RENESAS TECHNICAL UPDATE

Product Category	System LSI		Document No.	TN-RZ*-A0073A/E	Rev.	1.00
Title	Advanced 5port Switch (A5PSW) function issues and usage notice		Information Category	Technical Notification		
Applicable Product	See below	Lot No.	Reference Document	RZ/N1D Group RZ/N1S Group RZ/N1L Group User's Manual (See below for details)		
		See below

We would like to inform about issues and usage notice regarding Advanced 5port switch (A5PSW) function as described below.

Figure 1: Example of sending packets which corresponds to the bug conditions

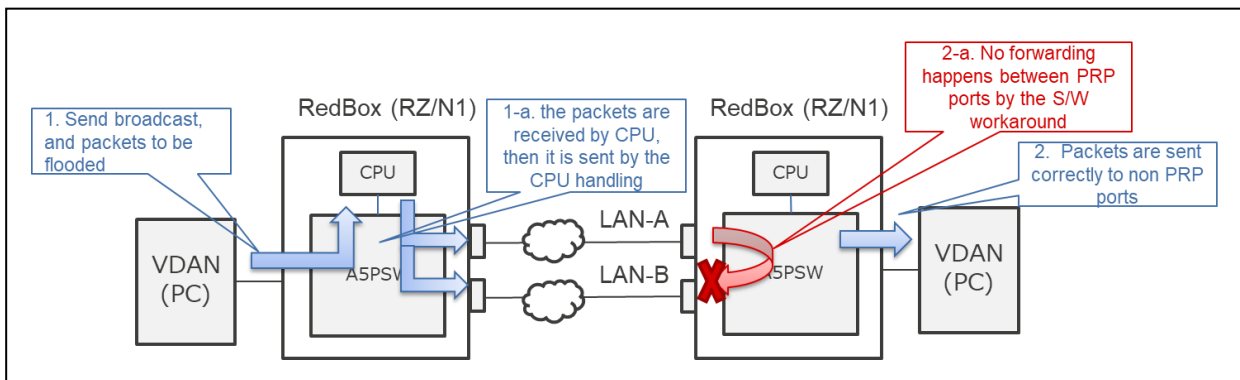
A5PSW (Advanced 5port Switch) forwards specific packets received at one PRP port to the other PRP port. According to the PRP specification, packet forwarding does not happen between PRP ports.

- Broadcast packets
- Packets to be flooded (Unknown unicast and multicast packets)

- Set 0 to the PRP group ports in the default mask registers (*) in order not to forward broadcast packet and unknown unicast and multicast packet.

(*) UCAST_DEFAULT_MASK, BCAST_DEFAULT_MASK, MCAST_DEFAULT_MASK

- Send packets which cause the bug, broadcast packet and packet to be flooded, by CPU handling.
i.e. Not using 5port Switch's PRP function for those packets

■ Case1: Sending packets which corresponds to the bug conditions

Figure 2: Example of sending packets which don't correspond to the bug conditions

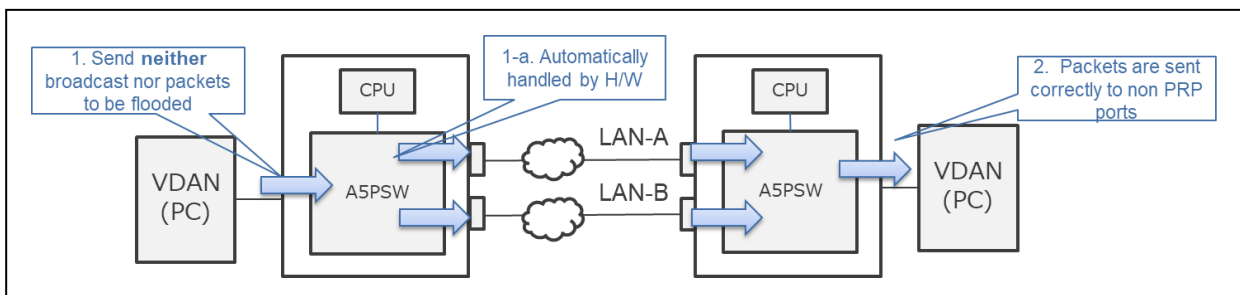
■ Case2: Sending packets which don't correspond to the bug conditions

Figure 3: Frame forwarding by mirroring function

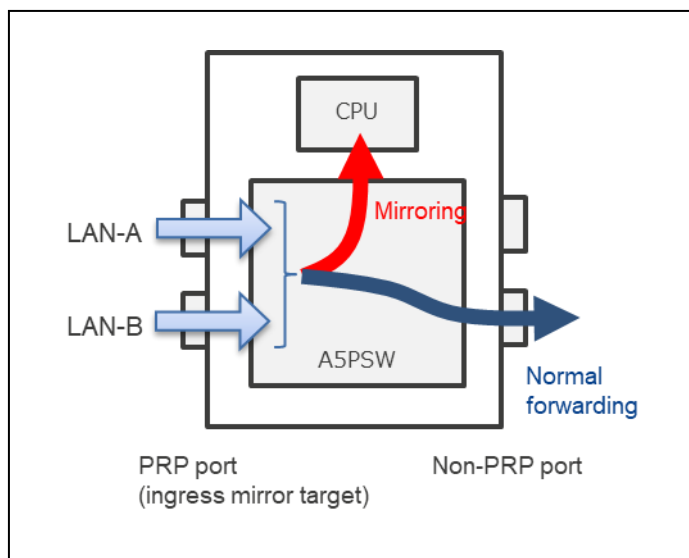
PRP Wrong ID LAN-A/-B Count Registers (CntErrWrongLanA and CntErrWrongLanB) do not work correctly. Even if LanId is attached incorrectly, it is not detected in these count registers.

It is prohibited to use PRP Wrong ID LAN-A/-B Count Registers (CntErrWrongLanA and CntErrWrongLanB). Workaround by software is the following.

1. Mirror the incoming frames on PRP ports to the management port with management tag to know which port incoming frame comes from, LAN A or LAN B.
2. Host CPU confirms all the frames from management port whether lanId is correct or not by SW, and software counter is incremented if it is incorrect.

In order to reduce CPU load, mirroring frames can be reduced by setting MIRROR_CNT register. Two options are available dependent on the situation as below, for example,

- Full inspection: for qualification you may want to be fully accurate, and mirror all the frames
- Production: here sampling 1 out of N frames would be sufficient to detect errors. In this mode MIRROR_CNT can be set to N to reduce the load on the CPU.

Figure 4: Timing of input and output frames in case of using Hub module

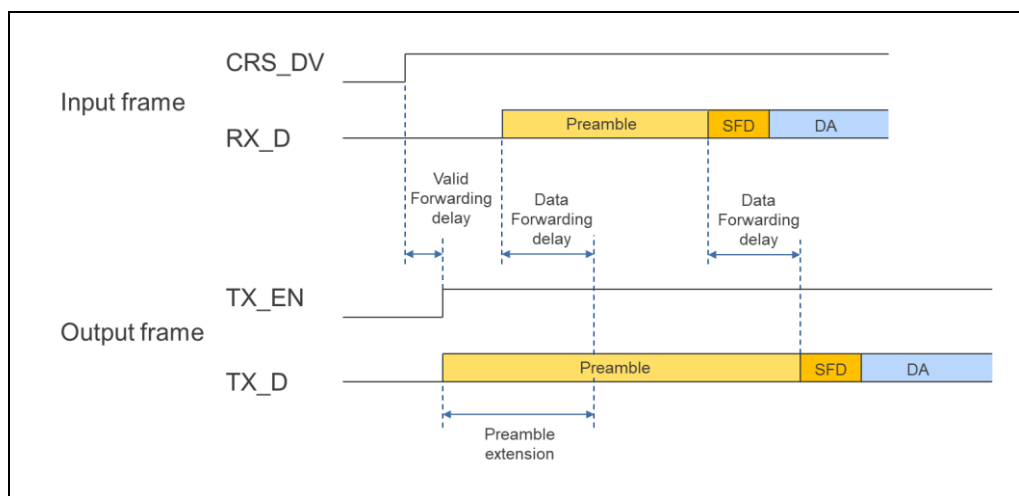
When using Hub module, preamble of the frame output from A5PSW is extended compared with input frame. This is used to indicate the frame transmission to the next devices and to avoid the collision as soon as possible.

From the Ethernet standard point of view, extension of preamble is permitted. However, it is found that some Ethernet POWERLINK support devices can't receive the frame with extended preamble. Therefore, do not use Hub module when supporting Ethernet POWERLINK.
